IMPORTANT: PRODUCT SAFETY NOTICE!

Subject: Siemens Warning Safety Notice: Customer ID# 1-2NA0-2793

WARNING SAFETY NOTICE

Figure 1 (LMD-frame circuit breaker example)

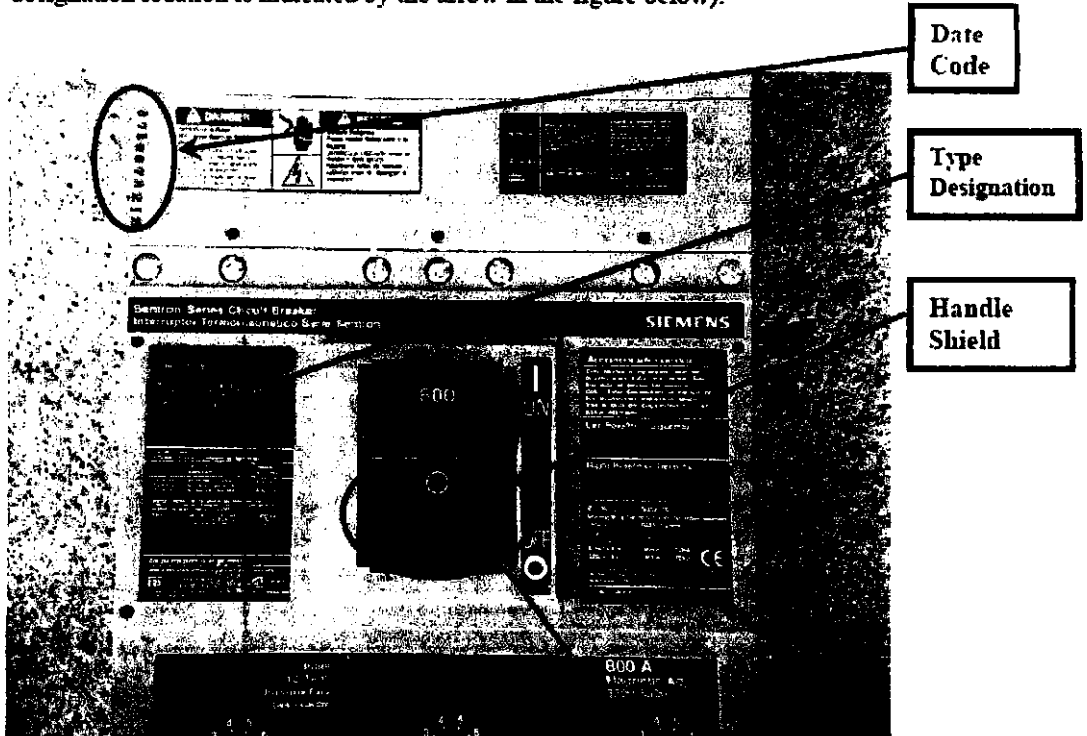
The potentially affected product manufacturing date can be determined by reading the first six digits of the ten digit string of number on the face of the device. The number is located on the front of the potentially affected products, above the words "Sentron Series" (see the circuit breaker example below). The format for the manufacturing date is MMDDYY**** where MM is the month, DD is the day of the month, YY indicates the last two digits of the year, and the asterisk symbol (*) signifies any number. Affected products manufactured during the time period of May 18, 2007 through August 8, 2007, must have the handle shield replaced. If there are white dots or raised letter "O" on either or both sides of the toggle handle, this indicates the shield has already been replaced and the date code does not need to be checked.

The device type designation is found on the front of the affected products (the type designation location is indicated by the arrow in the figure below).

White dots or raised letter "O" here, on either or both sides of the toggle handle, indicate that the shield has already been replaced and the date code does not need to be checked.
